**AGENDA  
DAYTON PLANNING COMMISSION MEETING**

**PLANNING COMMISSION  
STAFF REPORT**

**FILE NUMBER:** SDR 2022-11, MAJVAR 2022-11

**APPLICANT:** David Hakola

GROUND  
 DISTURBANCE PLAN

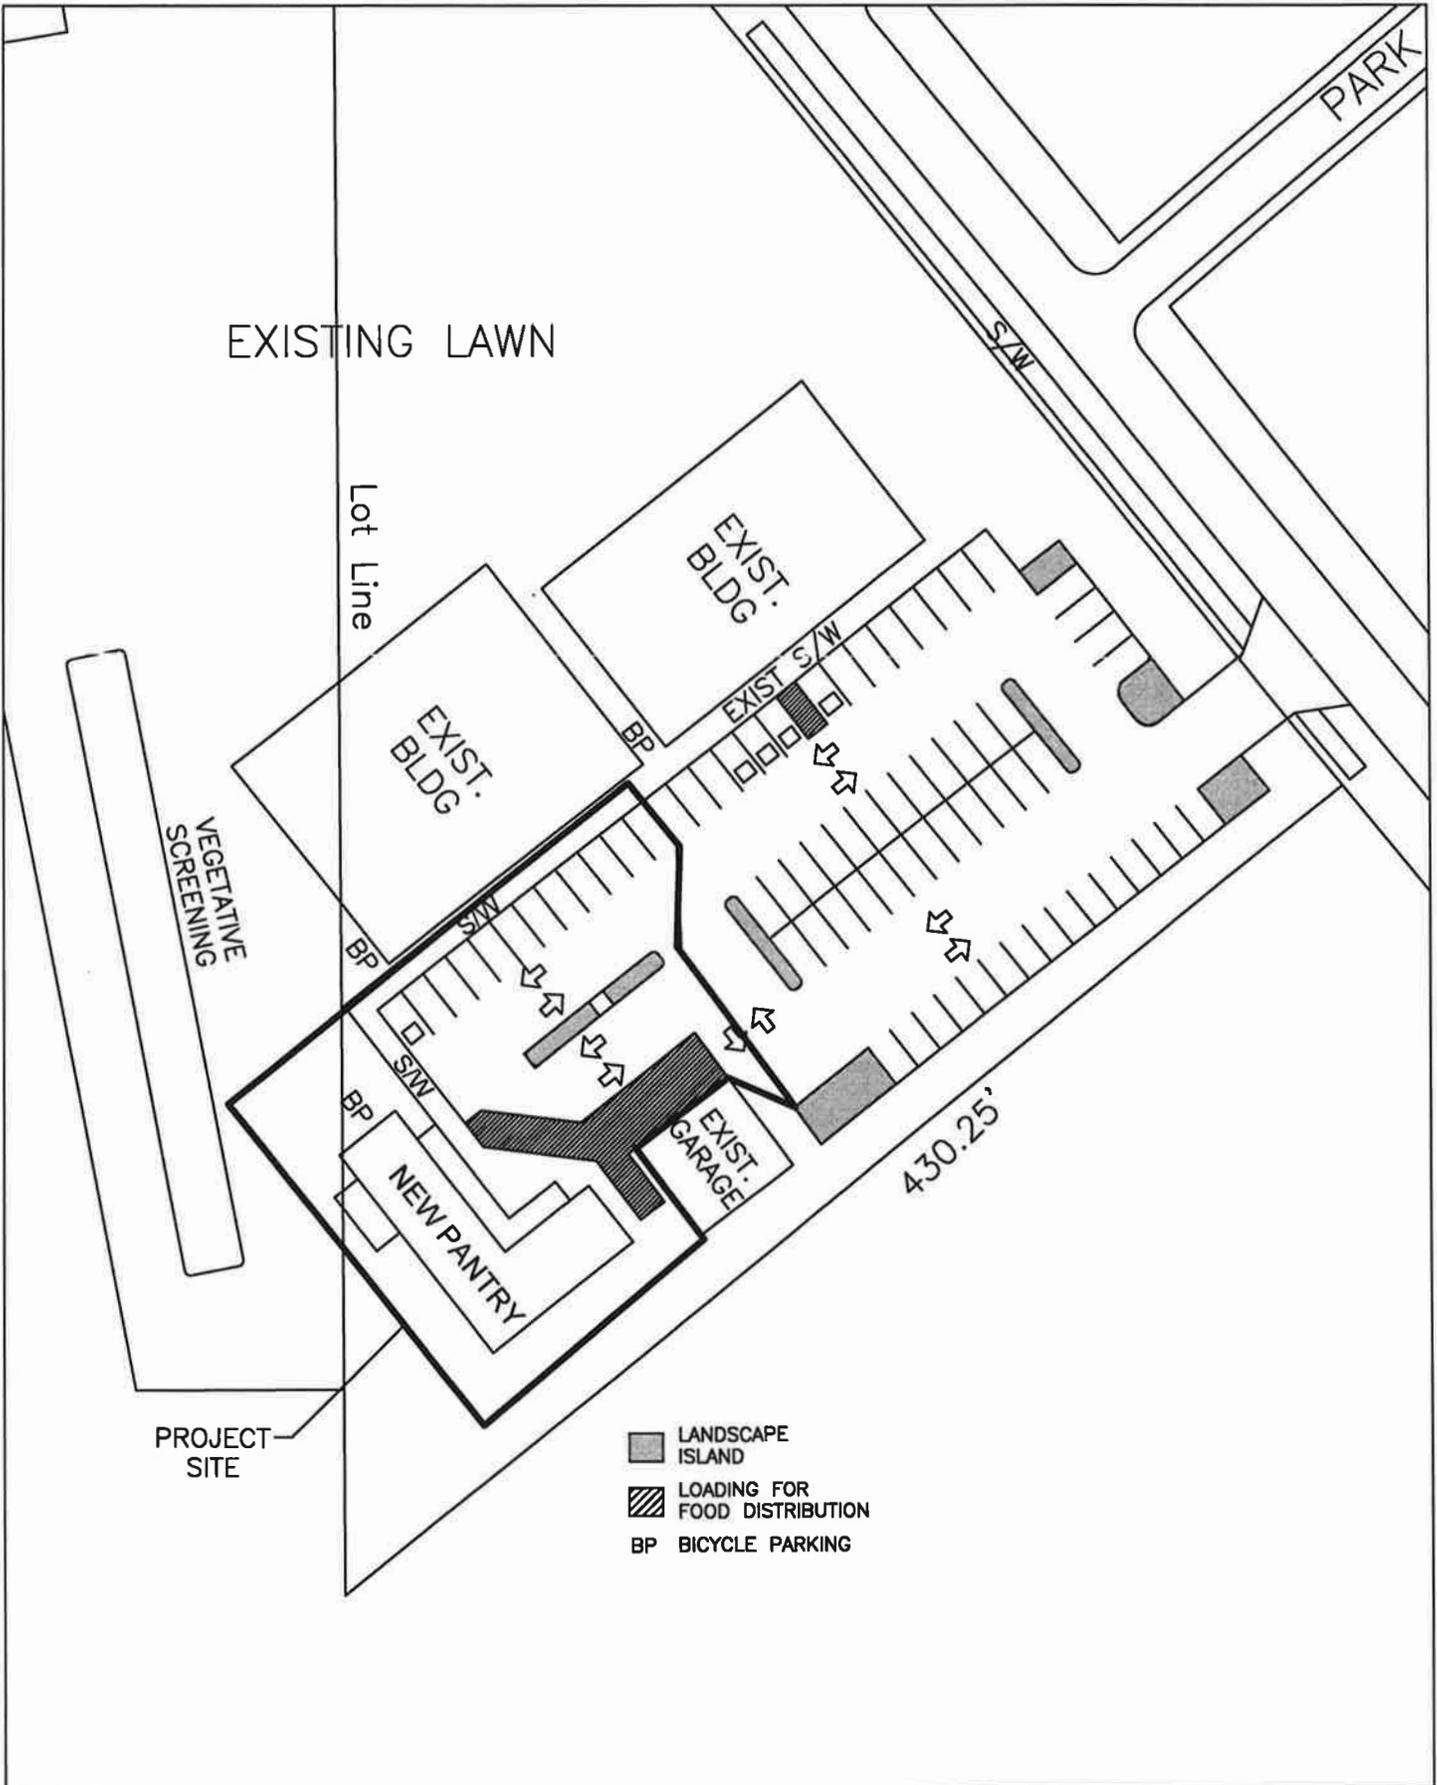
"The preliminary drawings did not include information on proposed storm drainage improvements to serve the new building and expanded parking lot. In particular, the location & type of detention system proposed is not clearly shown or defined and will need to be verified and worked out during the design review process. (Existing Storm Mainlines). Based on information provided by the development team at the pre-application stage, there is an existing private storm drainage system which may be able to provide service to the expanded parking lot and the new building (flowing northerly toward Ash Road). The actual alignment and connection point to the City or County storm system will need to be verified during design, as well as the exact alignment, material, depth, slope and condition of the existing pipes by the developer (by TV inspection of the pipelines, as applicable).

--- The developer will need to provide storm drainage improvements as required to provide for collection of drainage from impervious areas (ie. roof drains, driveways, parking areas, etc.). Detention Requirements. Detention will be required for this development to limit flows to predevelopment 5 year flows per PWDS requirements (PWDS 3.18).
